PLANNING SECOND REVIEW COMMENTS

Subject Property: 1292 Lancaster Drive NE

Reference Nos.: 22-111718-RP (Class 3 Site Plan Review)
22-111720-ZO (Class 2 Zoning Adjustment)
22-111721-ZO (Class 2 Driveway Approach Permit)

A-100

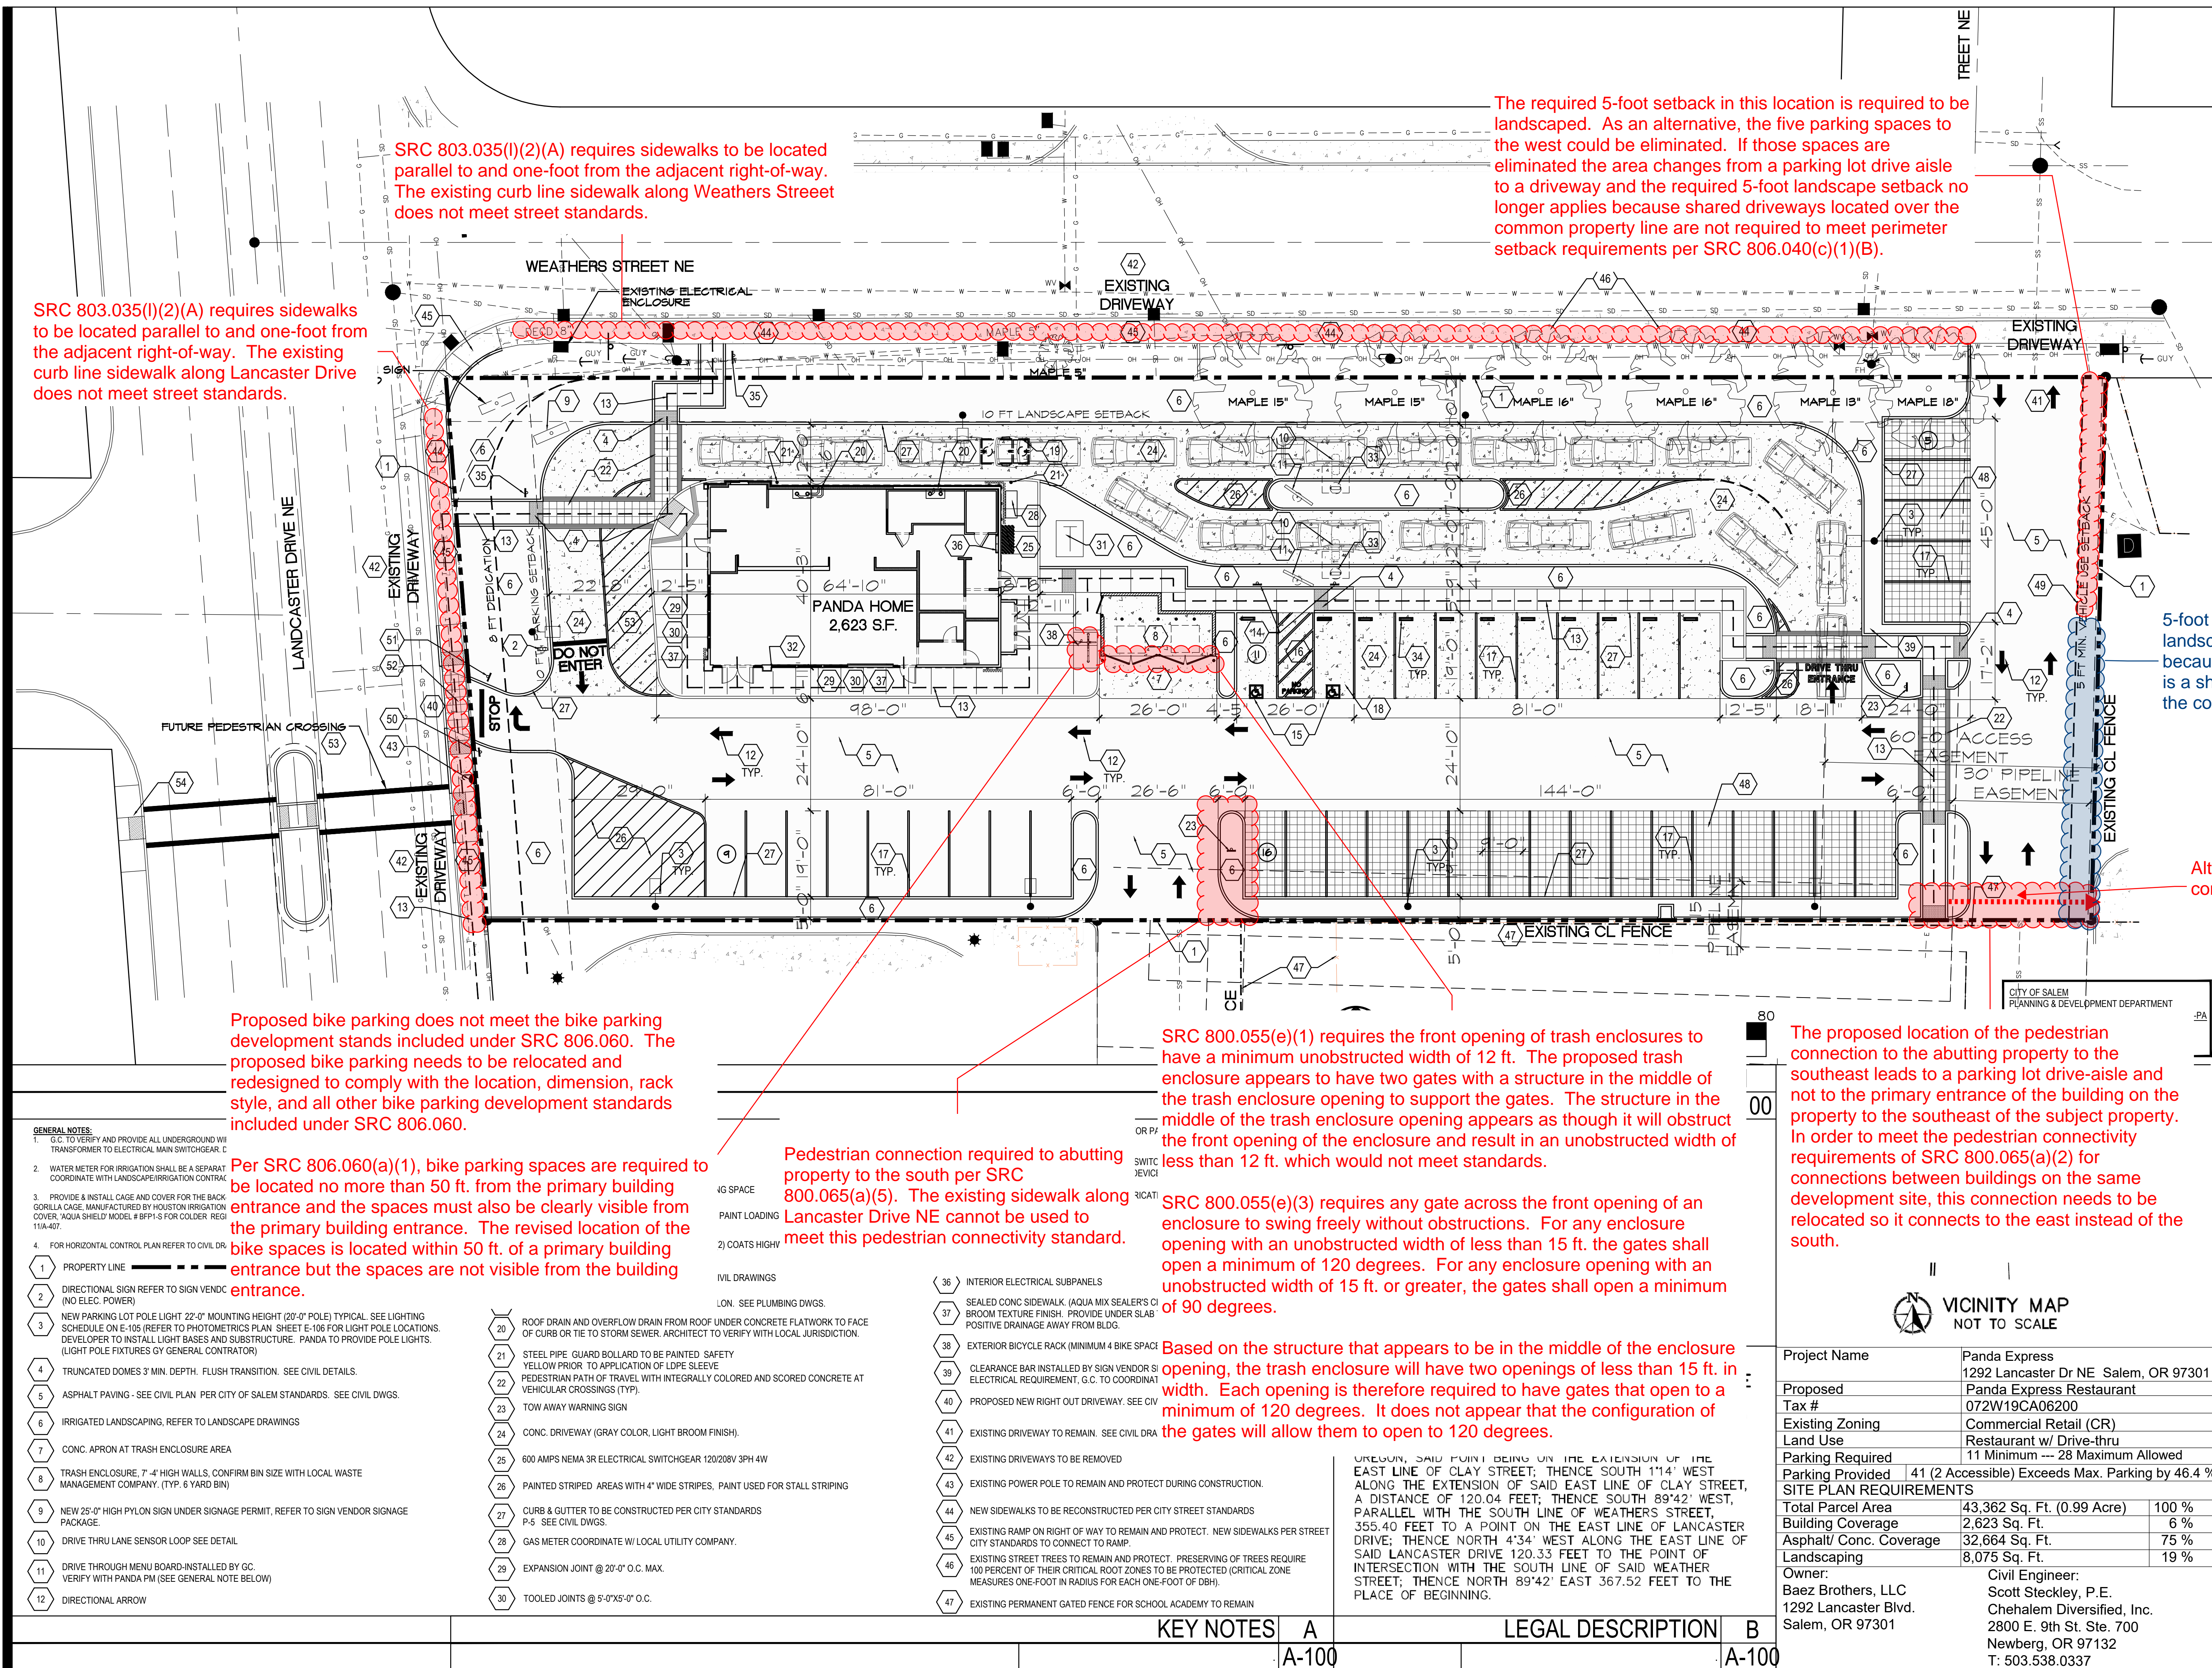
- 5-foot perimeter setback and landscaping not required here because this portion of the driveway is a shared driveway located over the common property line.

Alternative pedestrian
- connection location
